## **Landscape and Visual Impact Assessment & Landscape Matters**

### **Addendum**

**Circular Economy Hub at Huntstown, (to east of Mulhuddart) County Dublin**

**November 2023 / Project No. 7670**

**Figure 1 Development Impact Plan**

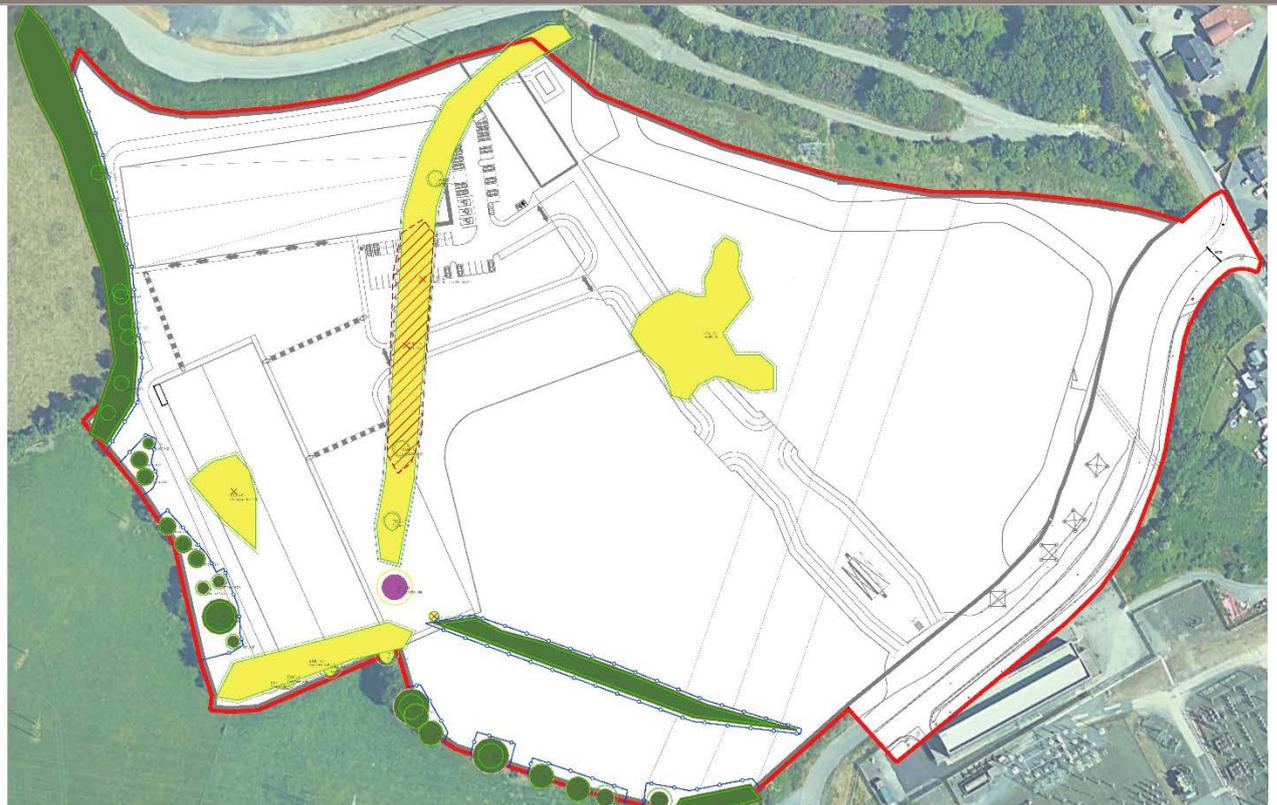
***4: A Tree Survey is provided at Appendix 8.1 of the EIAR. The tree survey was carried out in March 2021 and as such is outdated. The applicant is requested to submit a complete tree survey including an Arboricultural Impact Assessment, Tree Constraints Plan, Tree Protection Plan and Arboricultural Method Statement in accordance with BS 5837: 2012, Trees in relation to Design, Demolition and Construction - Recommendations is required. The tree survey and documents must be prepared by a suitably qualified arborist/ landscape professional.***

***5. The applicant is requested to submit a revised Landscape Plan to include for the requirements of Objective DMS0134 - Site Summary of Specimen Removal, Retention and Planting, of the Fingal Development Plan 2023-2029.***

- 2.3 Clearly the majority (99.6%) of the trees are rated as low or unsuitable for retention. This information was correlated with the topographical survey of the Application Site and the layout of the proposed

development to provide the relevant information required for Park Hood to prepare **Drawing No. 7670-L2700 Development Impact Plan**. This drawing demonstrates likely effects to existing landscape including to trees, hedgerows and vegetation compliant with BS 5837:2012 and outlines proposed protection measures to be provided during course of construction works.

Figure 2 Proposed Landscape Works to Western and Southern Boundaries

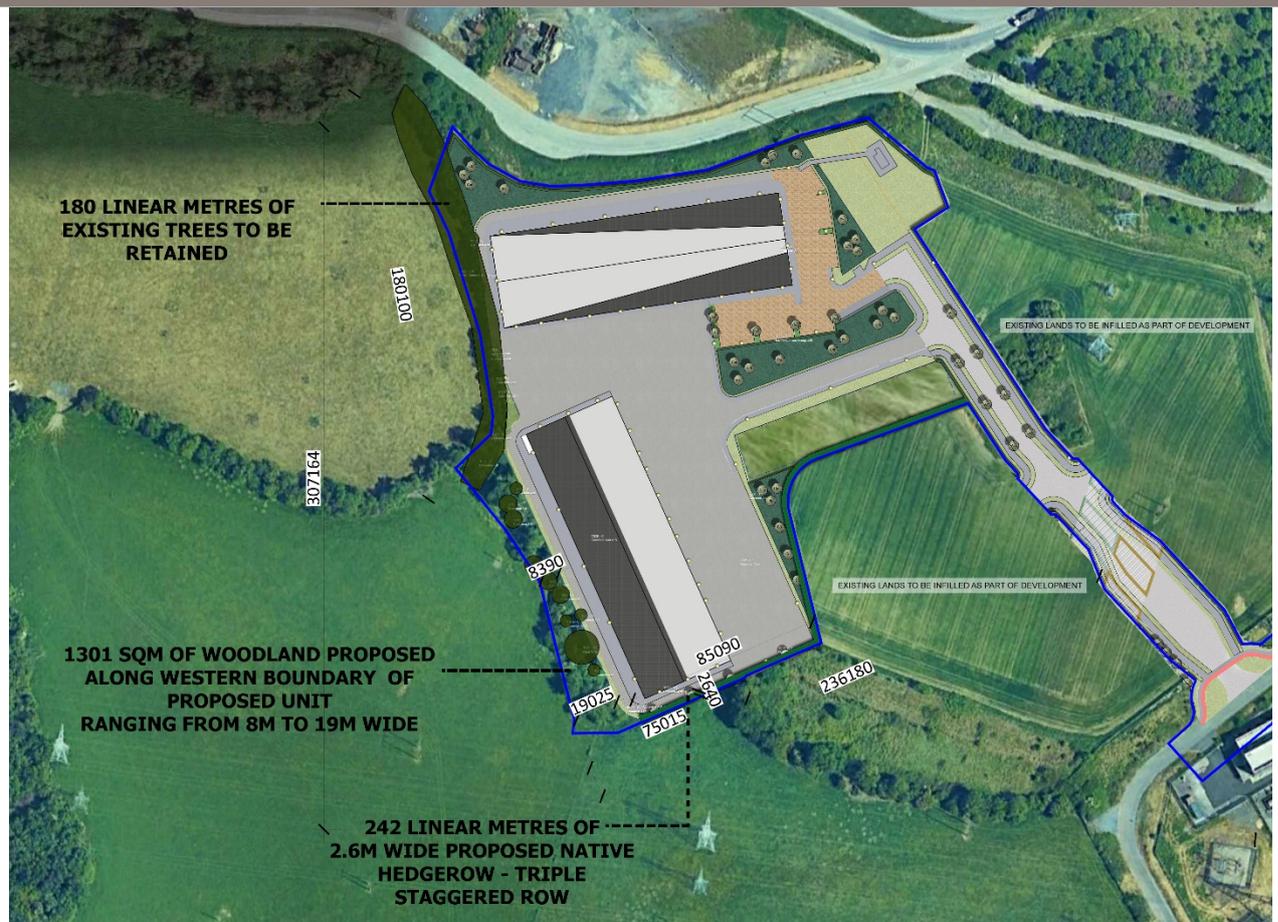
*14F: The documents submitted with the application, including the EIAR, acknowledges the significance of the trees and hedgerows on the western and southern boundary of the site. The documentation states that this boundary will be retained, protected and augmented. This boundary is also a townland boundary/ feature. However, it is considered that the proposed development does not make adequate provision for the protection, retention and augmentation of this significant cultural, ecological and landscape feature either in terms of appropriate setback - stated as being 7 to 10m in the planning and design statement (Section 4.2, Genesis Planning) - or in terms of its full retention. In many places, aspects of the proposed development are significantly closer to the hedgerow and in-part it is proposed to remove a section of the feature entirely. The applicant is requested to revise the layout of the proposed development so as to maintain the stated setback of 7m minimum from any aspect of the proposed development, including fencing, to the edge of the vegetation in the town land boundary. The revised layout shall have regard to the findings, including root protection areas, and any recommendations for retention of trees/ hedgerows of amenity value, in the updated arboricultural survey.*

- 4.4 Immediately to the south of the proposed Warehouse B is a section of hedgerow equating to approximately 75m. This includes 4 no. Ash (*Fraxinus excelsior*) trees surveyed as T007, T008, T009 and T010 for which the Tree Survey has recommended felling on the basis that they do “... *not merit retention due to disease*”. In and around the trees is a collective of “*single and multi-stemmed trees*” that were assessed as part of a group, T030. Again the Tree Survey has recommended their felling due to disease. It is therefore proposed that this collective diseased vegetation is removed and that the area between the proposed hardstanding associated with proposed Warehouse B and the

boundary is (re)planted with a replacement hedgerow. It is acknowledged that this area is thinner than the western boundary but, at 2.6m wide, there is sufficient room to provide an appropriate hedge made up of mixed native species. In total, based on a triple staggered row, this section would equate to 450 no. plants which, on maturing, would provide an improved buffer and screen over what is currently offered by the existing hedge.

- 4.5 This section would link into an internal hedgerow (total length 242m) that carries on along the southern boundary of the Phase One Application Site and, while positive in terms of the landscape character and amenity of the site, this would have little bearing on the matters raised for this specific FI Request.

**Viewpoint 1 - North Road (north of the Roadstone entrance and opposite entrance to Woodkraft).**

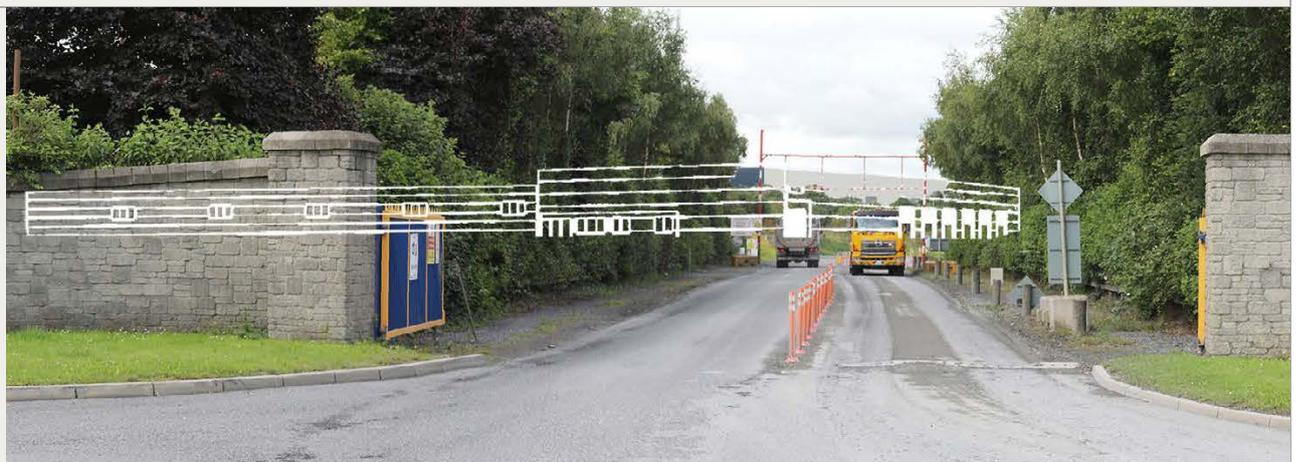
*14M:Photomontages of the proposed development showing the 'As Existing View', the 'As Proposed View' and the 'As Proposed Cumulative View' (where appropriate) should be submitted. The locations should include an open view, where available, from:*

- i. the vicinity of residential properties located west of North Road (north of the Roadstone entrance and opposite entrance to Woodkraft).*

- ii. *the vicinity of residential properties located west of North Road (south of the Roadstone entrance -at entrance to commercial unit).*
  - iii. *the existing entrance to 'Roadstone Huntstown' on North Road, and*

- iv. *the pedestrian bridge over the M50 to N2 slip lane.*
- 6.1 The four locations identified by FCC above were visited, surveyed and photographed on 21<sup>st</sup> July 2023 and this and the subsequent photomontages were undertaken in accordance with the “*Landscape Institute Technical Guidance Note 06/19: Visual Representation of Development Proposals*”. These include guidance on photographic technology, including camera selection, choice of lens and printing.

<p><b>Viewpoint Baseline</b></p>	<p>The section of North Road near the N2/M50 junction is essentially a cul-de-sac on account of its former route towards the city centre having been severed by the new road junction constructed around 2007. A link from the N2 connects to the R135 North Road to the north near Coldwinters but the c. 900m section to its south is closed off by bollards once at the lands Finglas ESB 220kv Substation. A pedestrian and cycle link continues to the south but vehicular access is not possible.</p> <p>The road is lined with incidental commercial properties and small groups of detached residential dwellings amongst which there are vacant lands and farmlands. It has a very mixed character with some properties having a refined boundary and well managed landscape in amongst which are areas that have a more degraded and dishevelled appearance. The sense of place is affected by the proximity of the Roadstone Huntstown quarry, the sub-stations / power stations, commercial premises and the nearby road infrastructure that all combine to limit the quality and sensitivity of this landscape.</p> <p>The quality and nature of roadside vegetation is very mixed and includes wooded belts and remnant field hedgerows that merge into newer hedgerows aside the entrance to the Roadstone quarry, commercial properties and around residential properties. The low-lying landscape ensures that there are no longer views afforded and views are often restricted to the road corridor itself. If views are afforded over weak sections of hedge across adjacent fields, they are ultimately closed off by an accumulation of further hedgerows or wooded areas though quarry plant, power stations, powerlines and large scale warehouses are often evident.</p> <p>To the immediate north of the site is a wooded area (extending to nearly 1.8 hectares) located between it and North Road that is a key factor in limiting views. The site to the north of the Roadstone Quarry entrance is set back by over 200m from the North Road so the influence of the site is currently very limited due to distance and intervening vegetation.</p> <p>There are no designated views noted in this area within the Fingal Development Plan and there are nothing on this section of road that is noted in terms of landscape, scenic or amenity provision that would be a factor in ensuring that any views would be rated as being of an significance.</p>

<p><b>Viewpoint Sensitivity</b></p>	<p>Medium to Low</p>
<p><b>Predicted Change</b></p>	<p>As demonstrated within the wirelines for these three viewpoints, Warehouse A and B and the wider development will be set back at such a distance to ensure that it is either visually obscured by intervening vegetation or, where visible, its introduction would not have an unacceptable or adverse effect on the view. The effects are therefore rated as negligible to the vast majority of North Road. Where there are glimpse views as in Viewpoint 1, there will be a slight effect though given the intervening landscape view and visual context, the magnitude of change is low.</p>

Proposed tree and hedgerow planting is to be undertaken to the north and north-east of Warehouse A but the development would not need to rely on this for effective integration.
<b>Summary</b>	Negligible to Slight; not significant.
